**PLANNING COMMISSION STAFF REPORT
CONDITIONAL USE PERMIT USE2024 0007
HEARING DATE: MAY 14, 2024**

PROPOSAL: Expansion of Community Center from 7,625 to 9,984 square feet. Parking shared with neighboring buildings.

STAFF RECOMMENDATION: Approval with conditions.

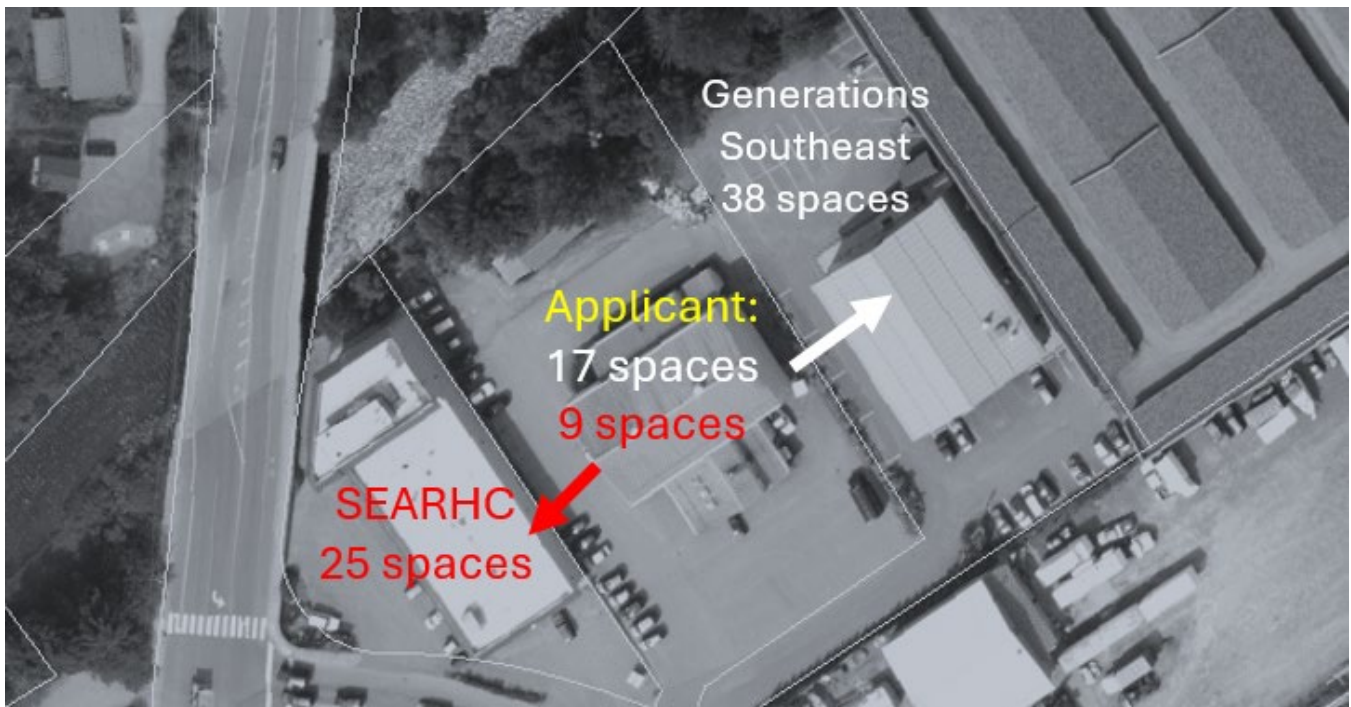
The expanded facility is required to have one loading space that is 30 feet by 12 feet, with an unobstructed height of 14.5 feet. The width of the proposed loading space north of the structure is 9 feet 10 inches.

While code compliance is verified during the building permit process, the condition proposed clarifies that the Commission approval of a project does not include reduced dimensions for a loading space.

Condition: Prior to issuance of a building permit, the Applicant must provide a loading space on site that meets the requirements of 49.40.225(c), "Dimensional Standards and Signage for required off-street spaces."

SHEET NO.
C002

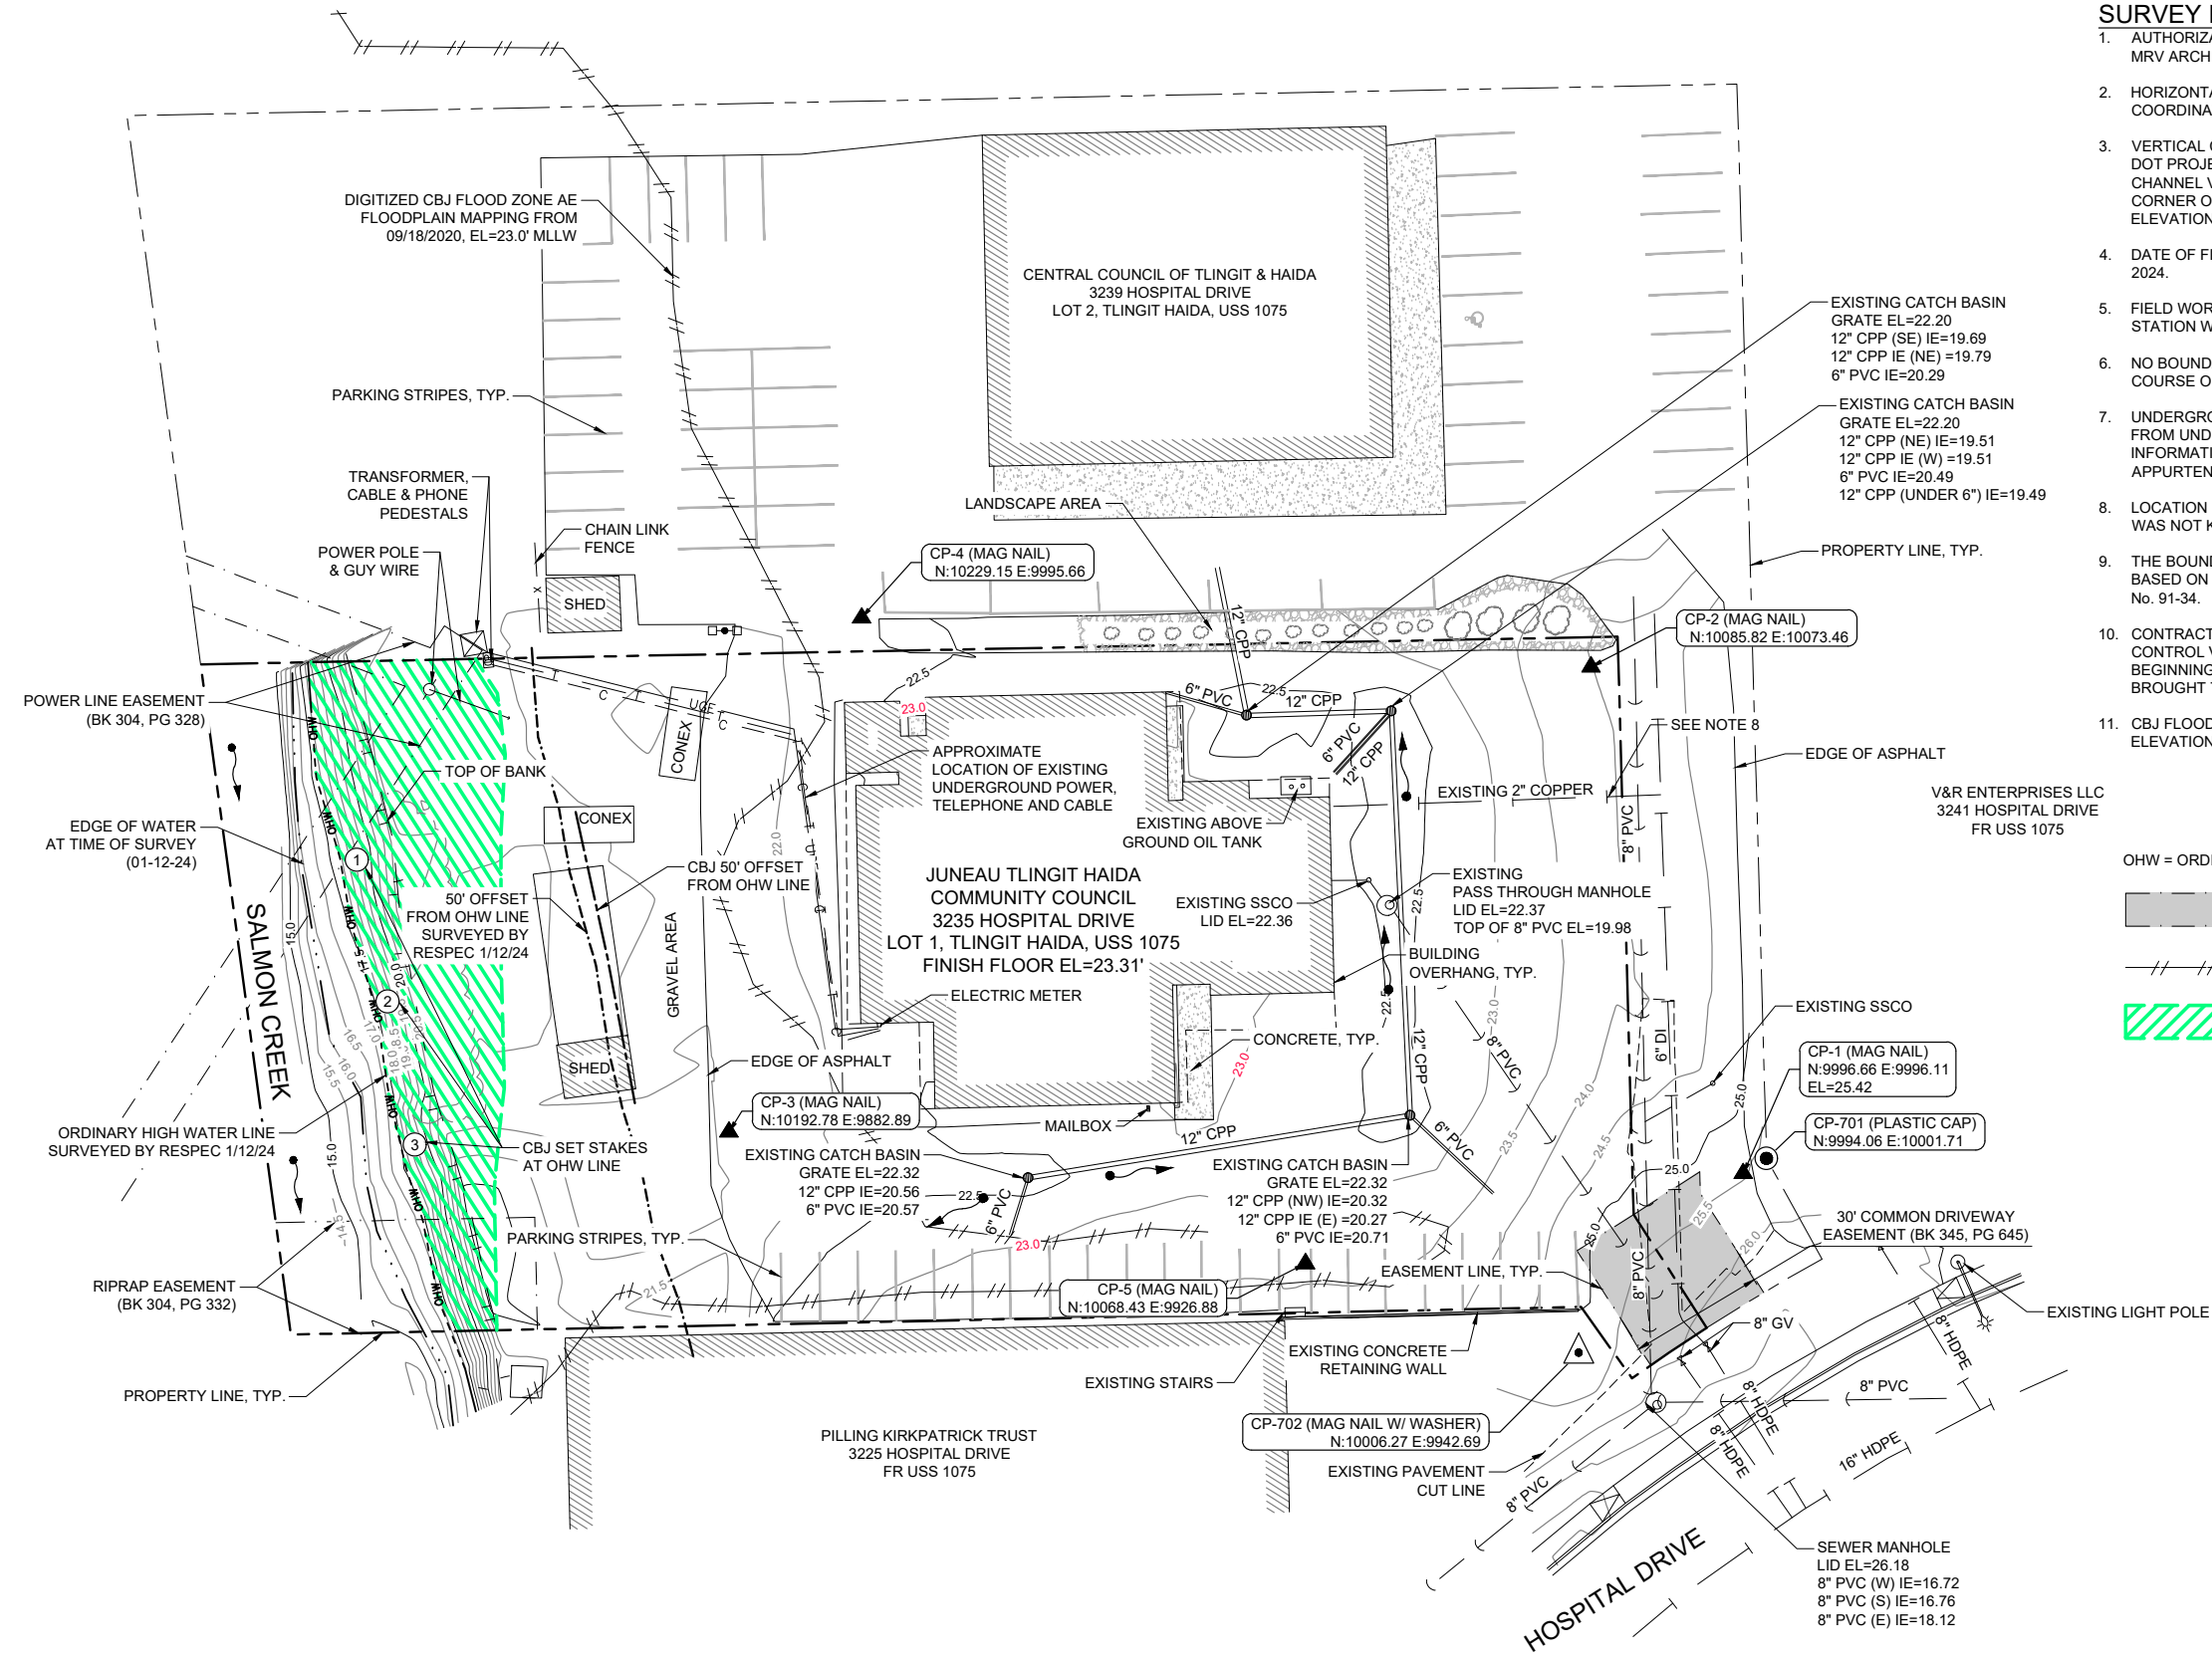
Current vegetative cover is shown on the site plan (**Attachment A, Sheet C002**) at 4,308 square feet, or nine percent.

Habitat - The lot abuts Salmon Creek, an anadromous stream. The site plan illustrates development, including off-street parking, is outside of the 50-foot development setback. An existing shelter and smokehouse built in the setback will be removed (**Attachment A, Sheet C002**), improving conformity and compliance.

1. Prior to issuance of a building permit, the Applicant must provide a loading space on site that meets the requirements of 49.40.225(c), "Dimensional Standards and Signage for required off-street spaces."
2. Shared parking agreements with 3225 Hospital Drive cannot exceed provision of nine spaces on the Applicant's lot.
3. Prior to issuance of a building permit, the two structures located in the no development buffer must be removed.

SHEET NO.
A151

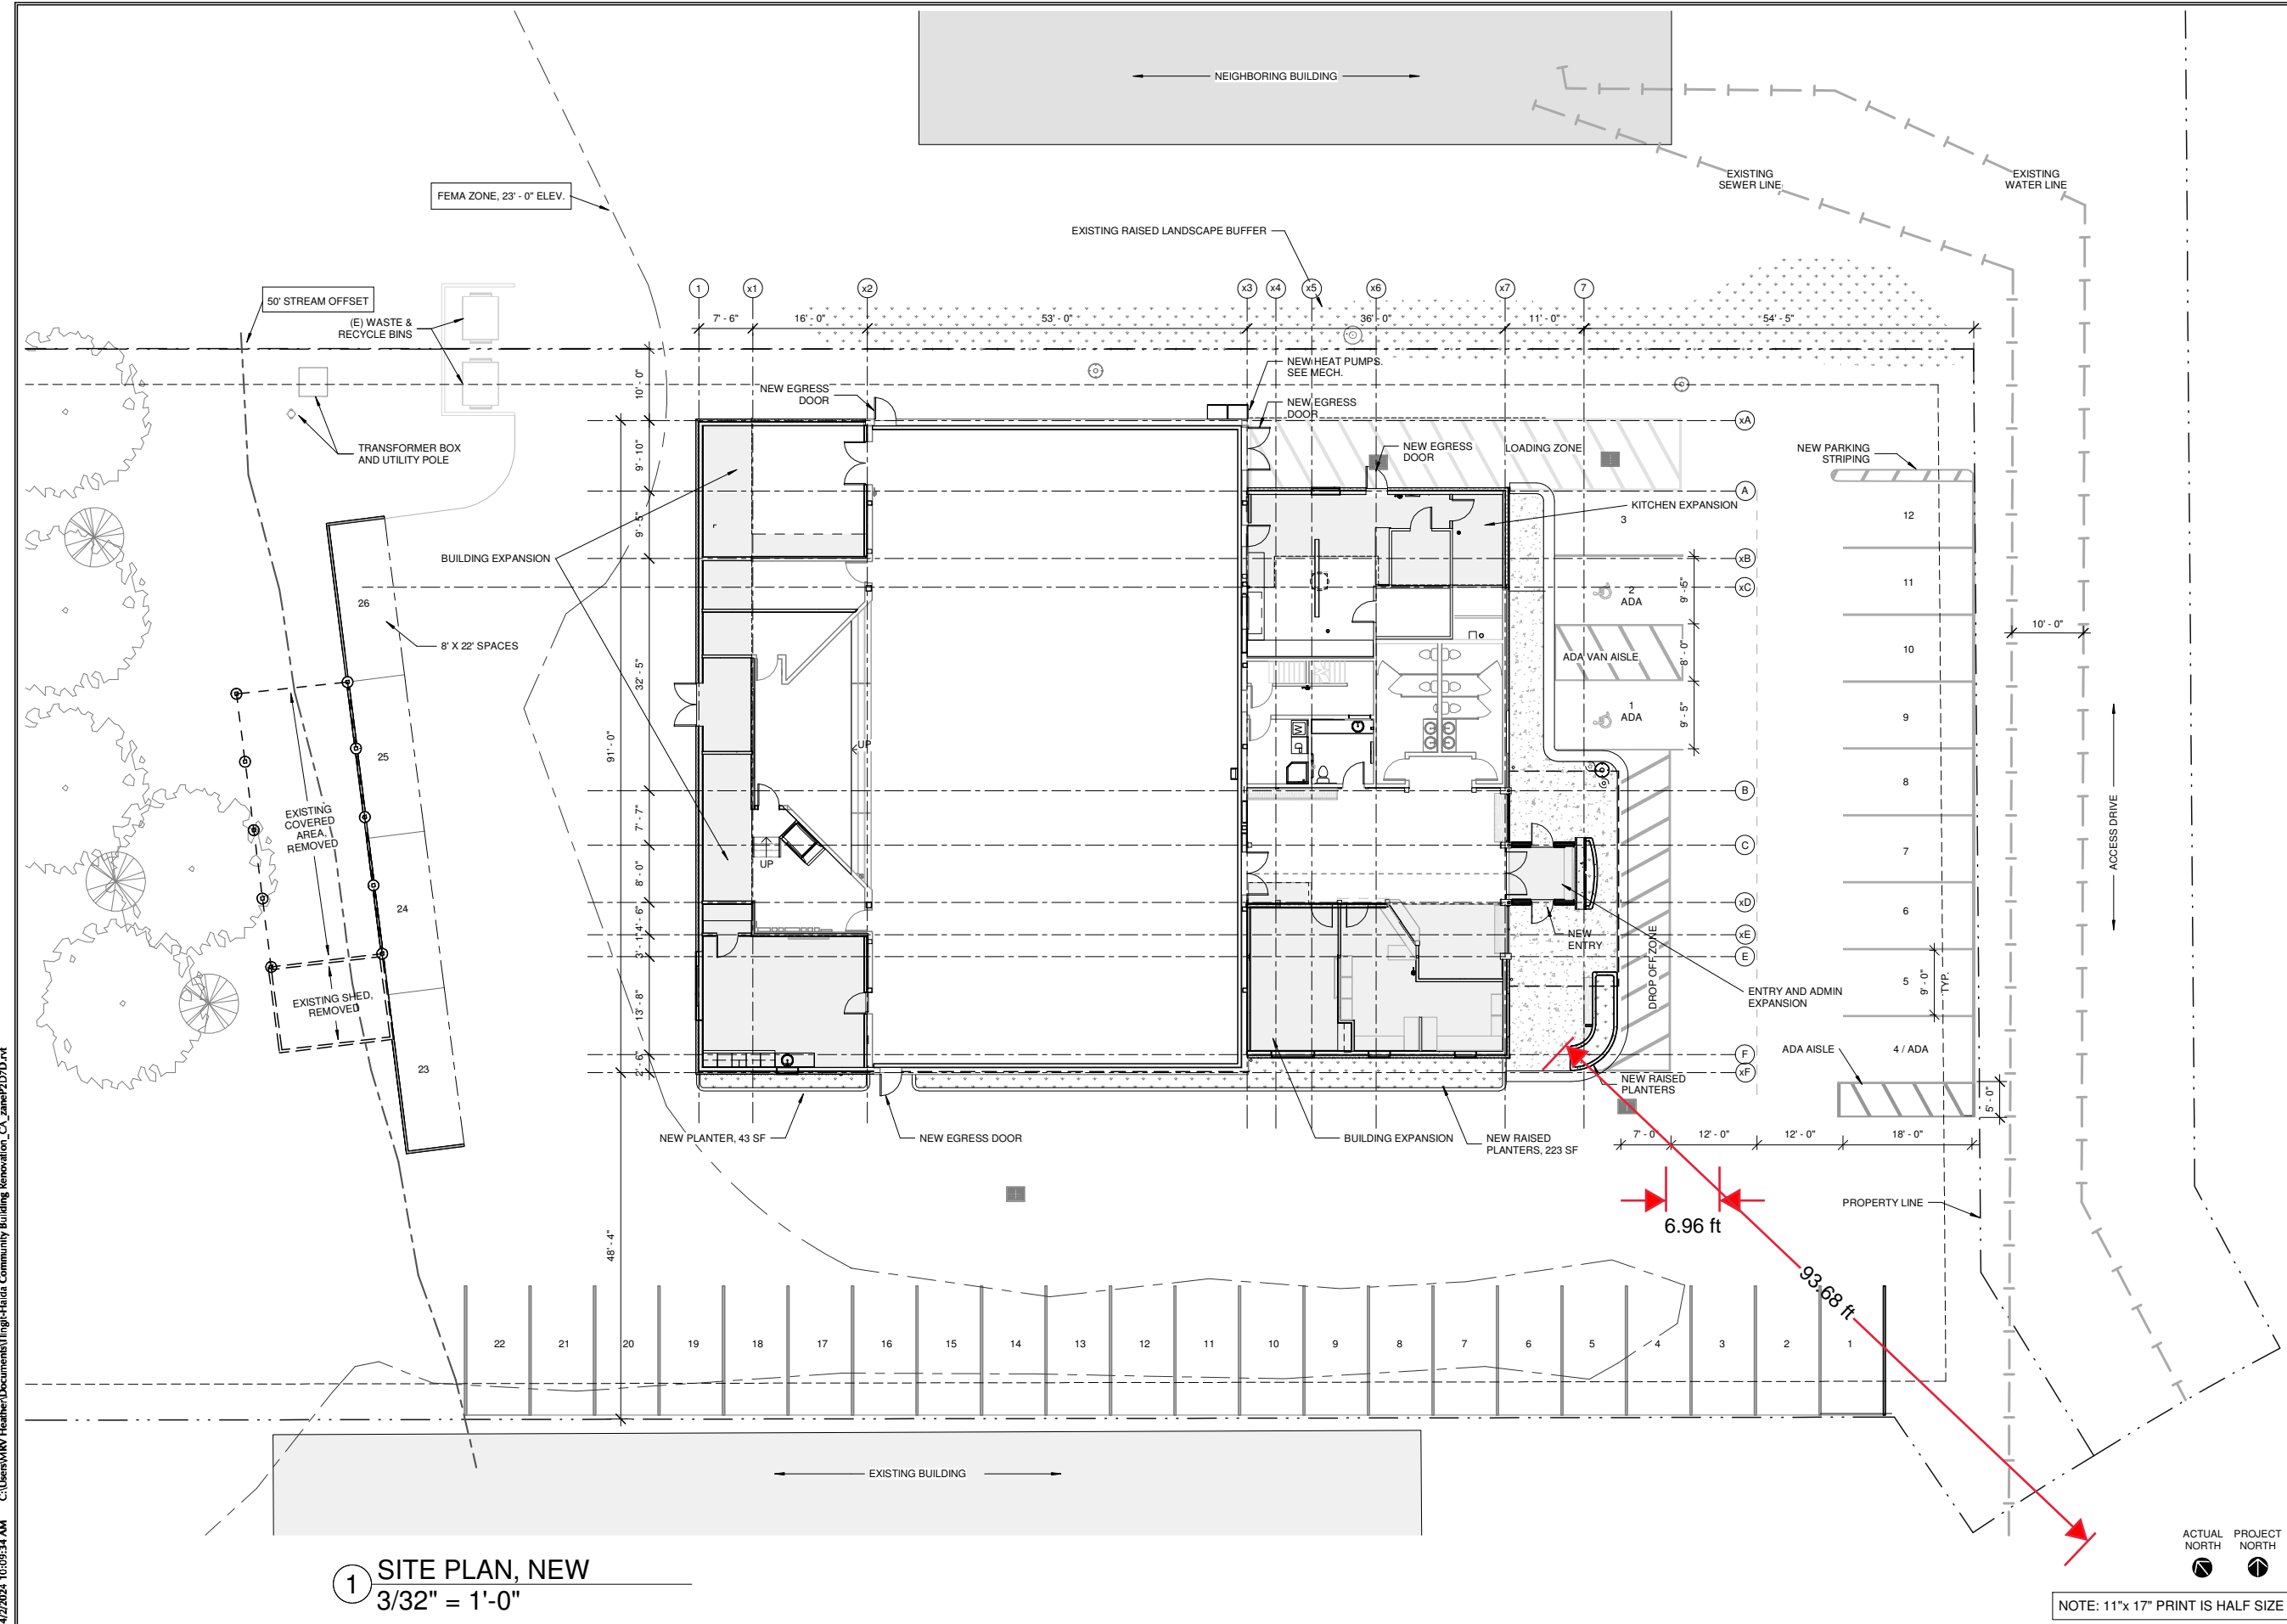
Three accessible parking spaces are required, with one providing van accessibility. The proposed site plan includes two van accessible parking spaces near the entry of the structure, and a third ADA space across the drive aisle from the entrance (**Attachment A**, Sheet A151).
